7 March 2012

**TITAN READINESS CENTER
MEAD TRAINING SITE
HVAC REPLACEMENT**

PROJECT No. 310086

ADDENDUM NO. 3

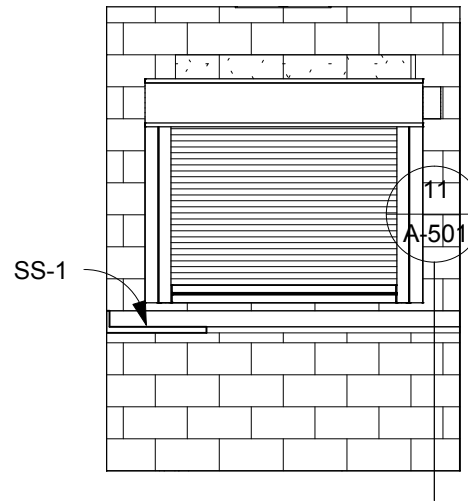
- 1-55 In reference to the drawings, sheet S-102 and to addendum #1 dated 22 February 2012, item 1-24. Replace sheet S-102 with the attached sheet S-102, dated March 6, 2012.

Drawing #	A-204.1
-----------	---------

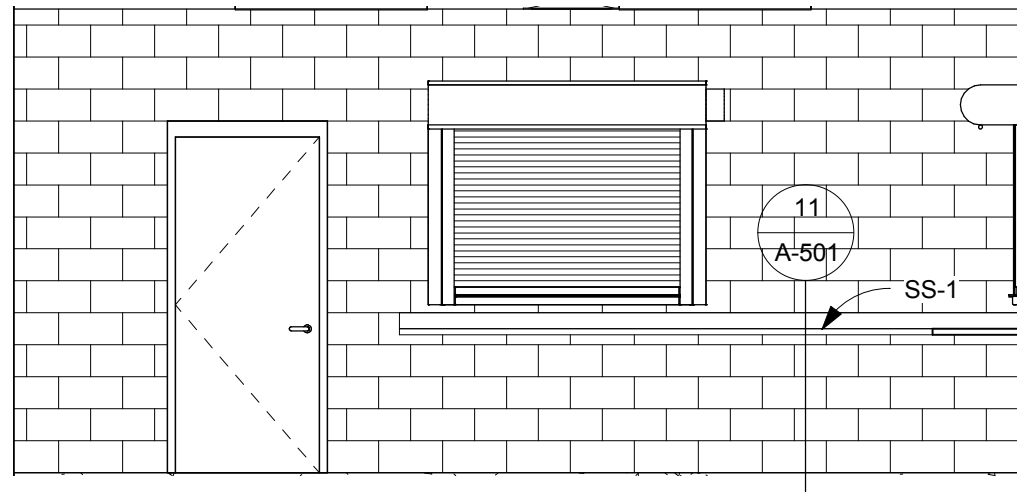
- 1-66 In reference to Sheet A-204, add Elevations 18 "Armorer – West Elevation & 19 "Armorer – South Elevation. See attached sheet A204.1
- 1-67 In reference to Sheet A-502, Detail 9, change the note "3/4" HARDWOOD BASE" TO READ "1 1/2" HARDWOOD BASE."

Drawing #
A-503.1

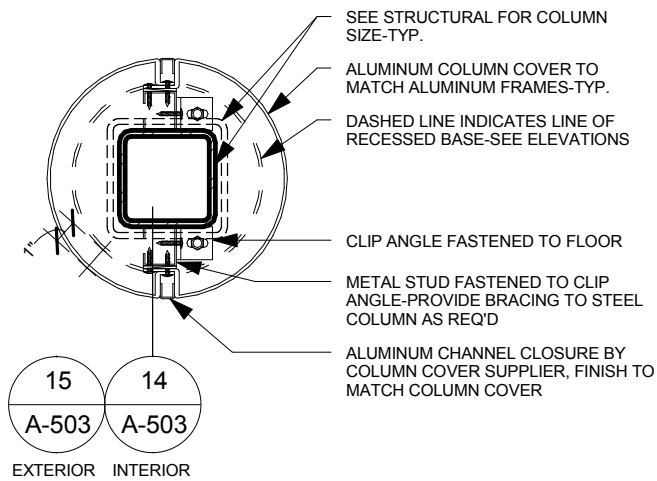
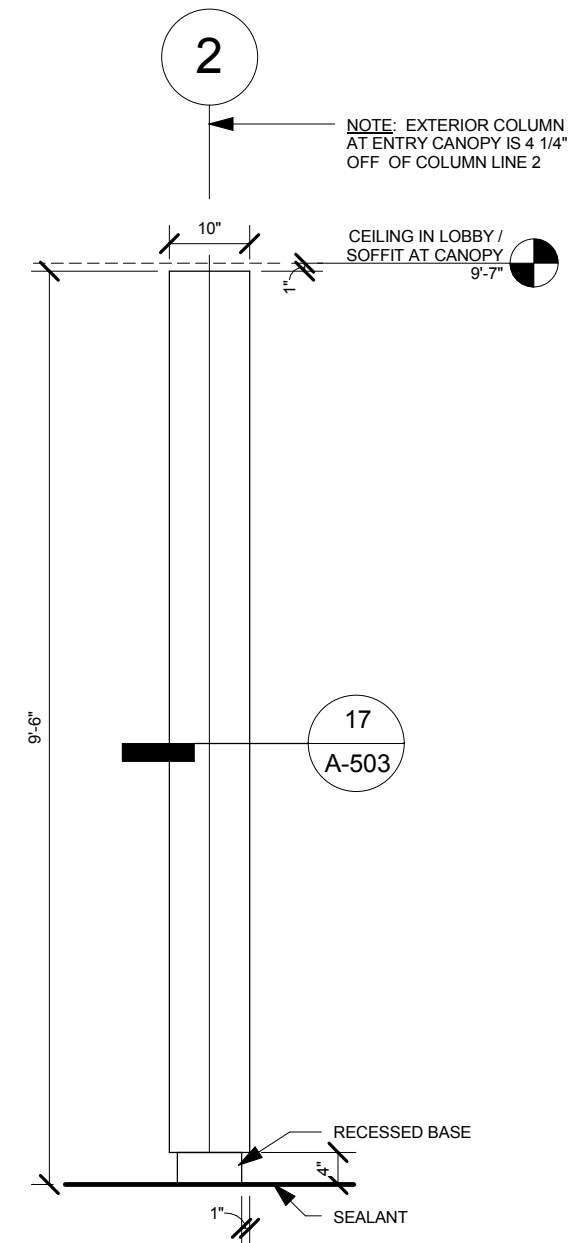
- 1-68 In reference to Sheet A-503, Column Cover Elevations, add Detail 17- Column Cover Plan – 10", add Column Cover Elevation and add the following items to the COLUMN COVER SCHEDULE in Detail 11, See attached drawing A-503.1:

- Column ID 2-ENTRY / Height = 9'-6" / Dia. = 10" / Comment = CAP & SEAL TOP OF COLUMN COVER
- Column ID 2-MEZZ / Height = 9'-6" / Dia. = 10"
- 1-69 In reference to Sheet A-505, add the structural footing, foundation and reinforcement information to Details 2, 4, and 13 indicated in the attached Drawings A-505.1, A-505.2, and A-505.3.

From Sheet	for CA use:
Drawing #	
A-601.2

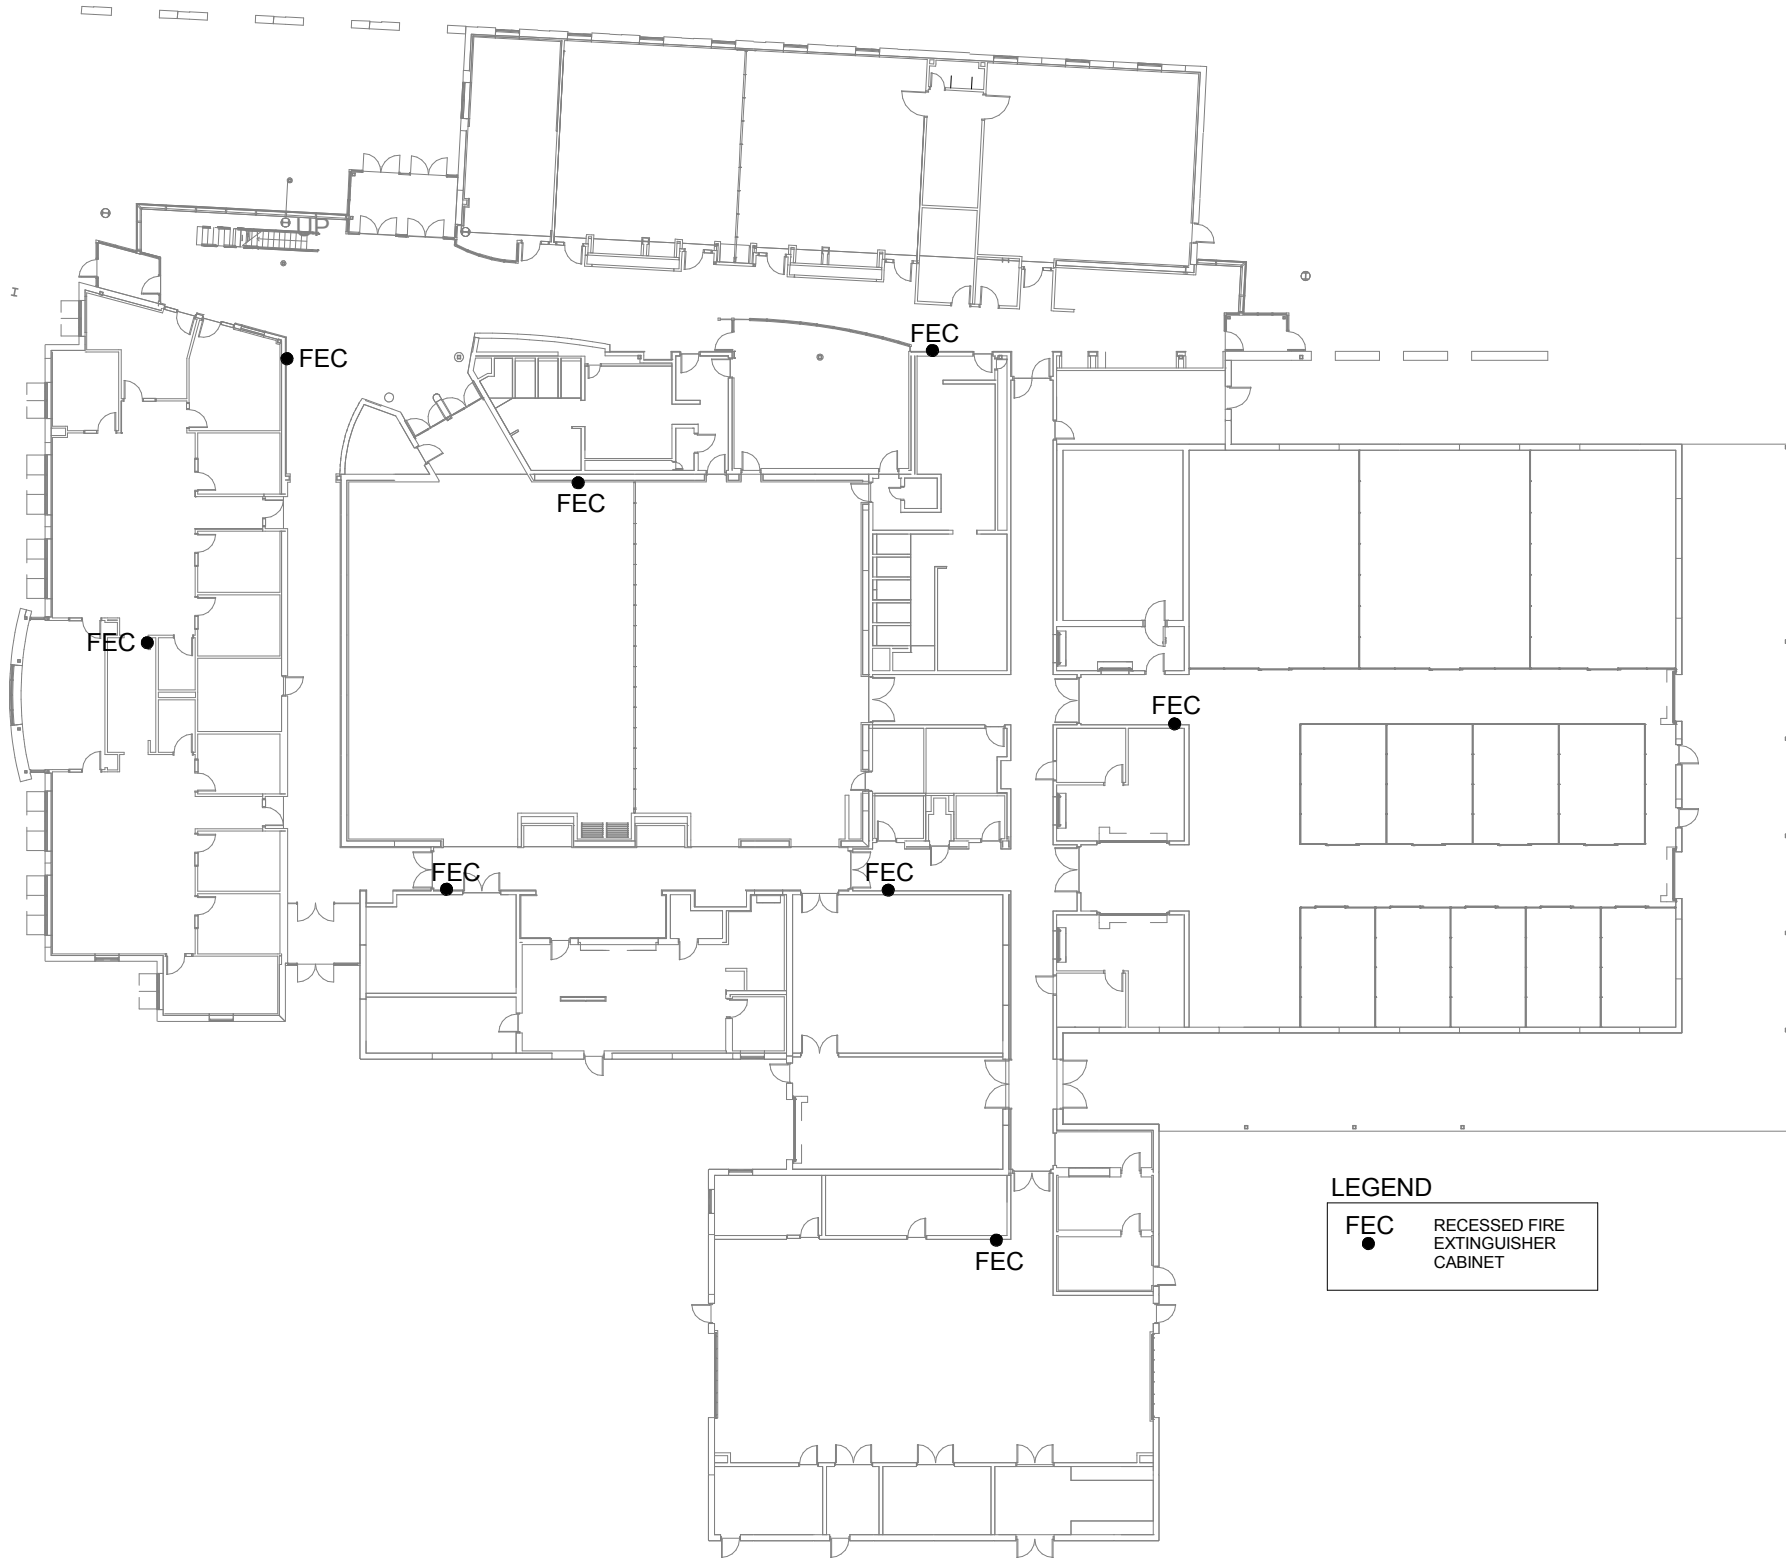
- 1-71 In reference to Sheet A-601, add the Fire Extinguisher Cabinet Key Plan, see attached drawing A-601.2. In addition to this Fire Extinguisher Cabinet Key Plan, refer to food service drawings for location of kitchen fire extinguisher.
